**Economic and Social Council**Distr.: General
27 July 2012

Economic Commission for Europe**Inland Transport Committee****World Forum for Harmonization of Vehicle Regulations****158th session**

**1958 Agreement – Consideration of draft amendments
to existing Regulations submitted by GRE****Proposal for Supplement 16 to Regulation No. 50 (Position,
stop, direction indicator lamps for mopeds and motorcycles)****Submitted by the Working Party on Lighting and Light-Signalling***

"Annex 1

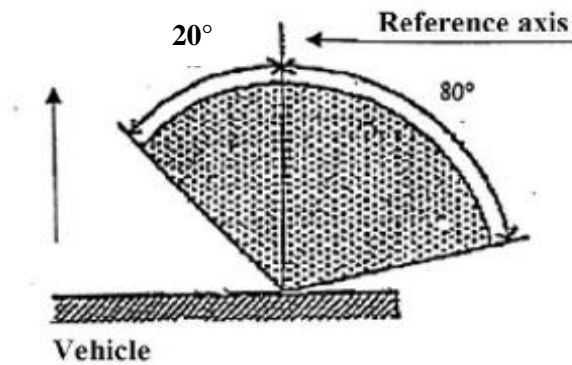
Annex 1, amend to read:

Minimum horizontal (h) and minimum vertical (v) angles for spatial light distribution

Front position lamps (for a pair of lamps)

V = + 15 degrees / - 10 degrees
